ADDENDUM NUMBER 3

DATE: 03/25/2019

PROJECT: Shelby Township Activities Center

SHEET NO. **A111**

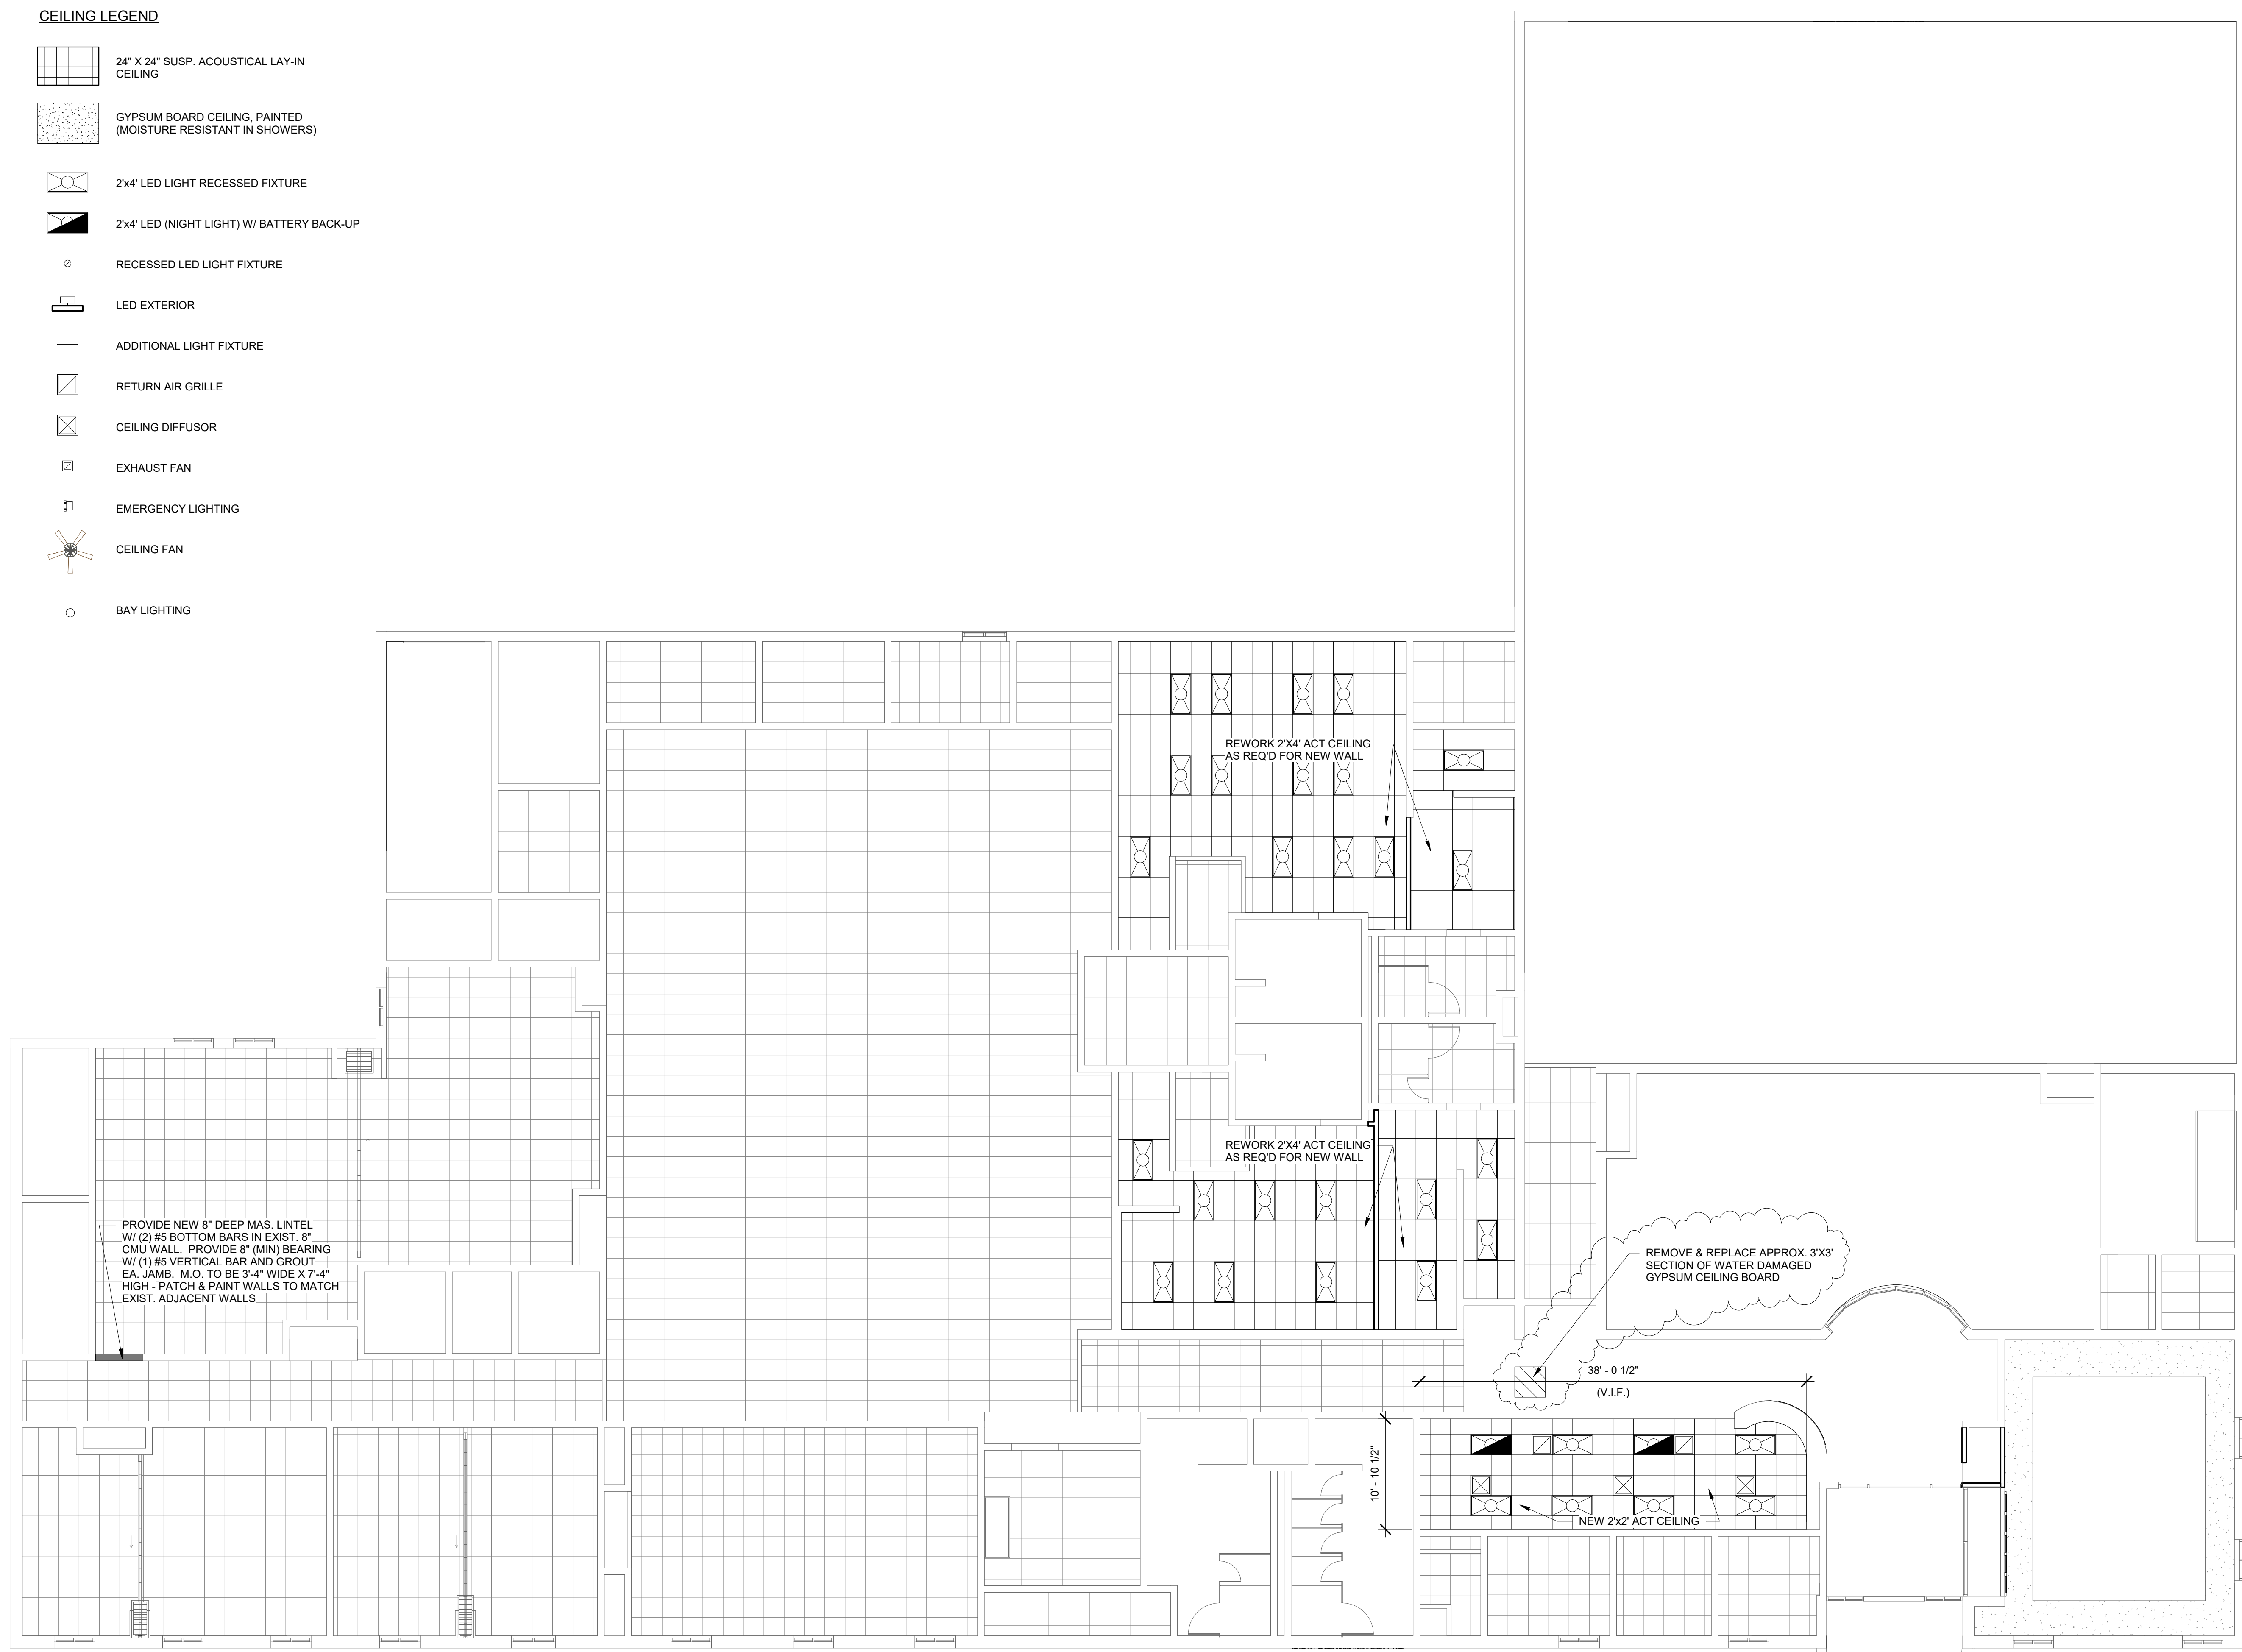
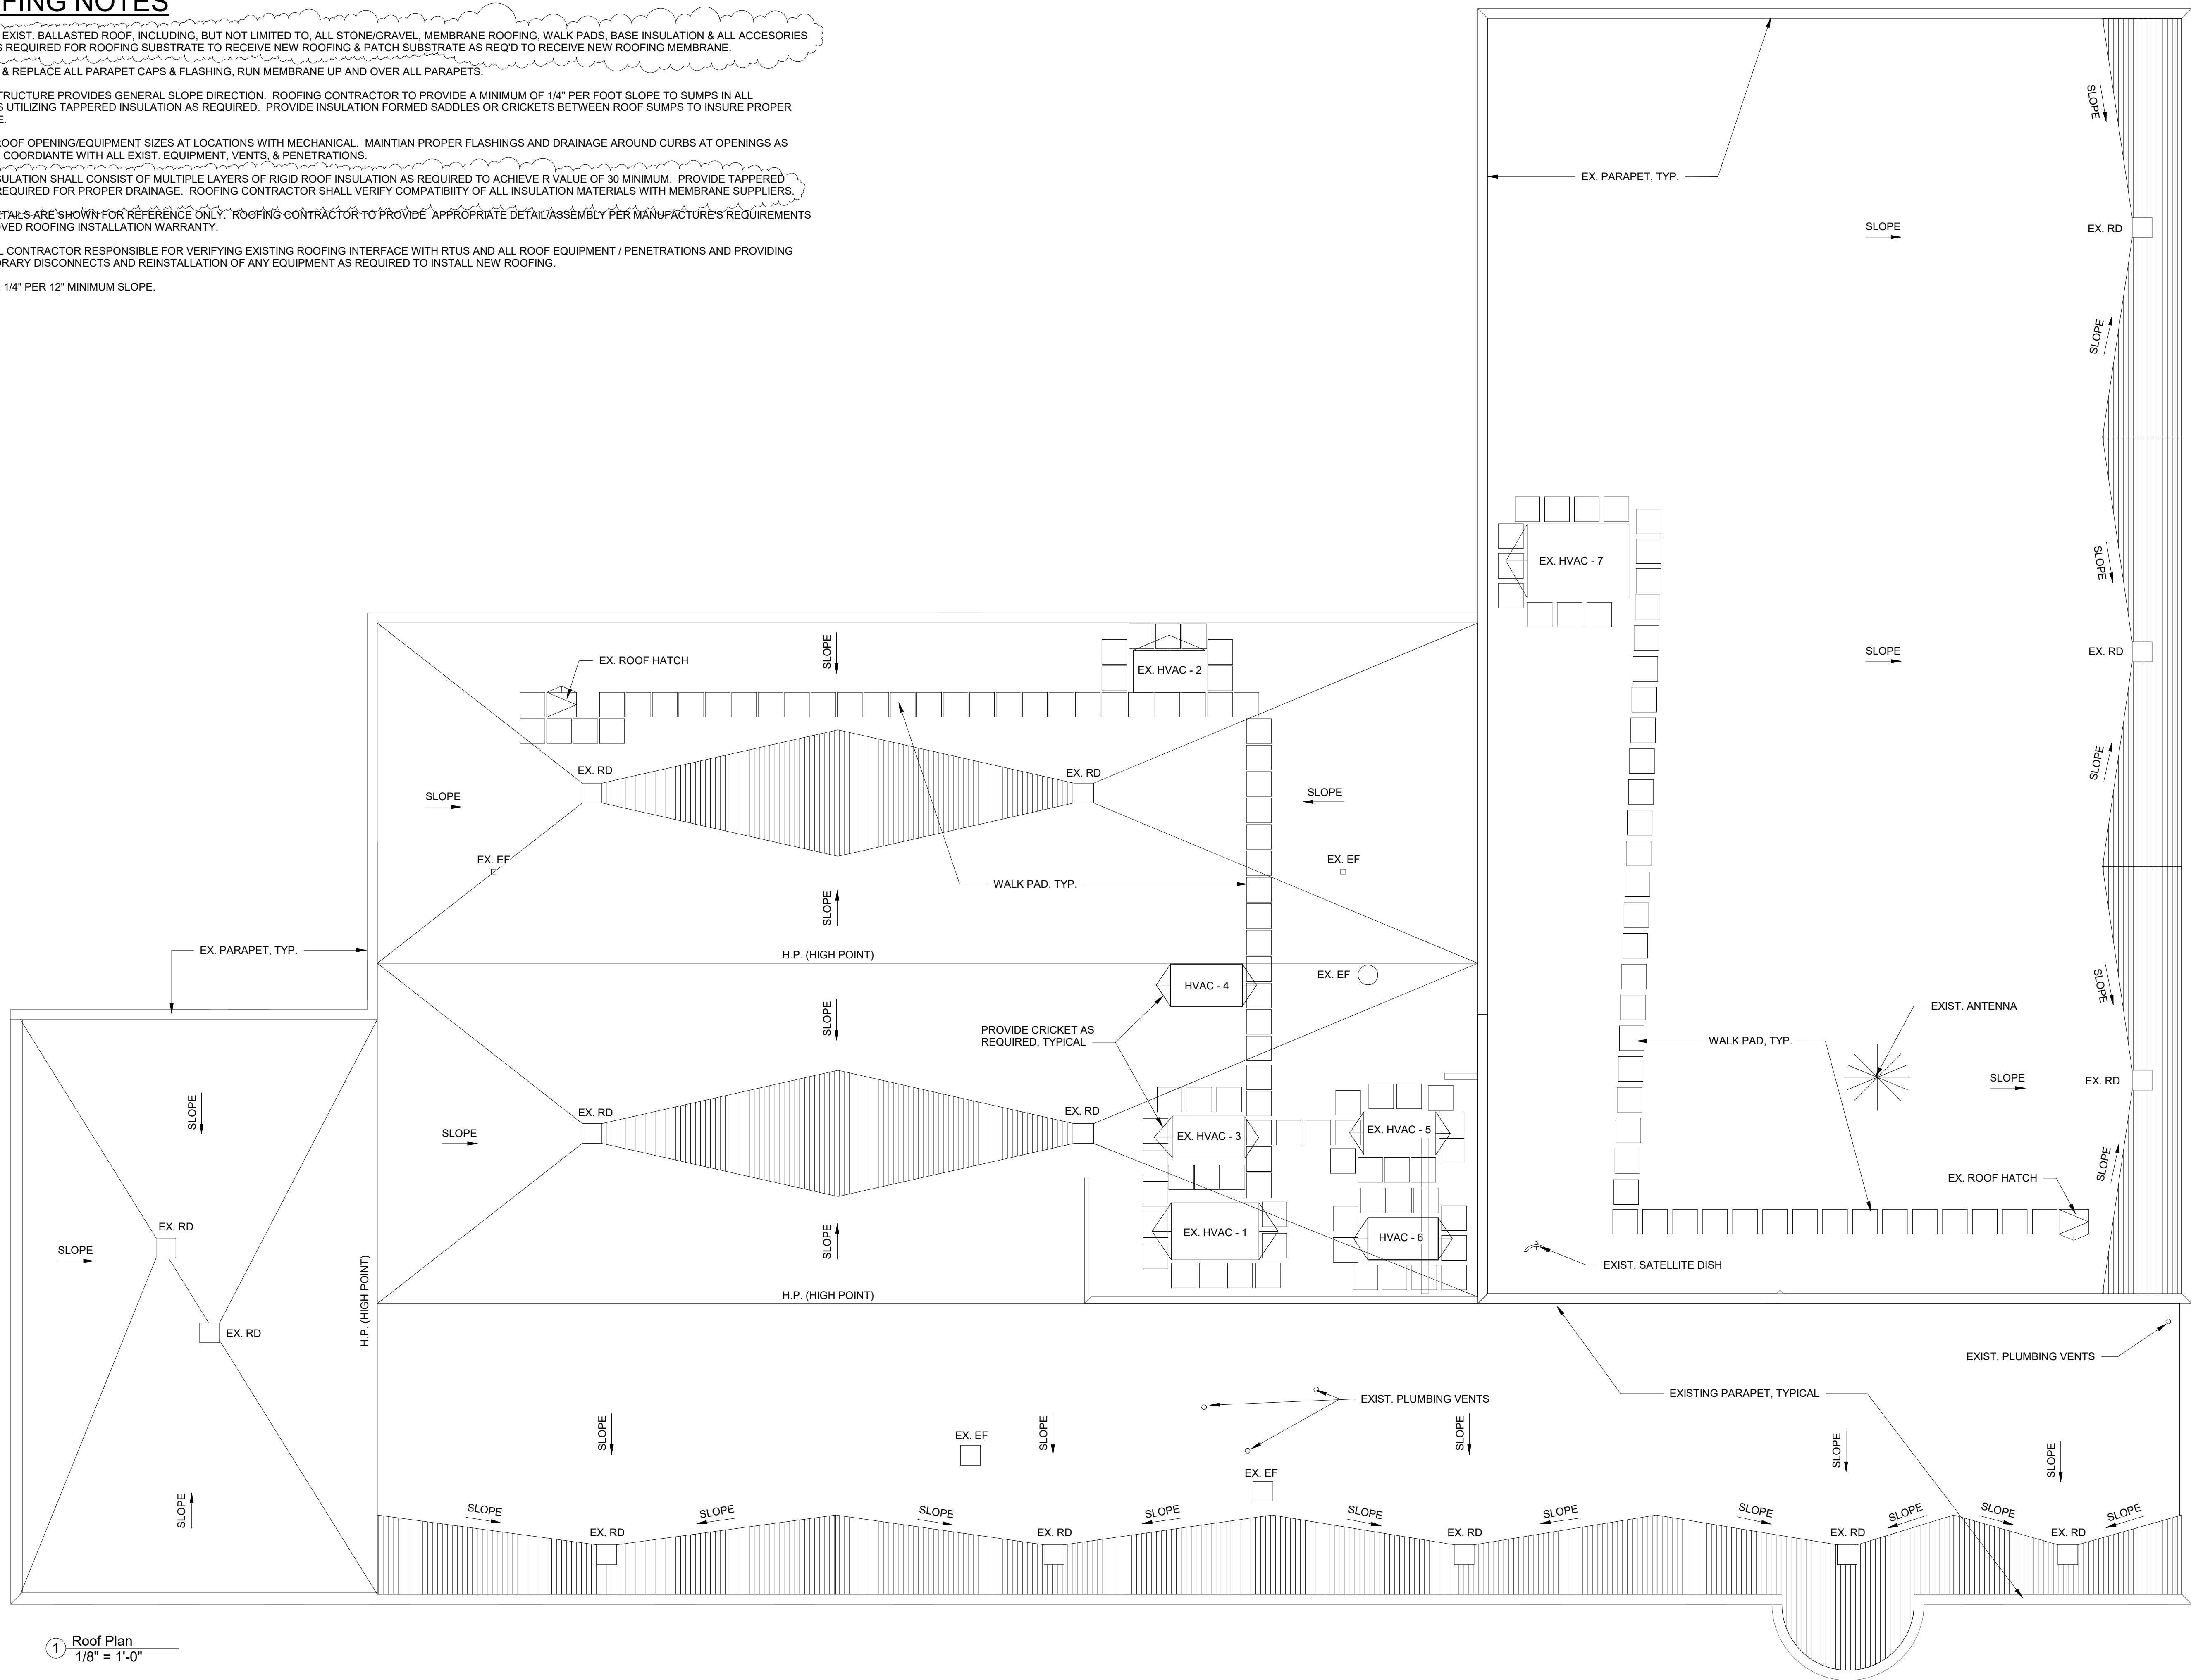
1. SHEET A111 (reissued)
 - a. Added not to replace section of water damaged gypsum ceiling board.
2. SHEET A121: (reissued)
 - a. Revised note 1.
 - b. Revised note 5.
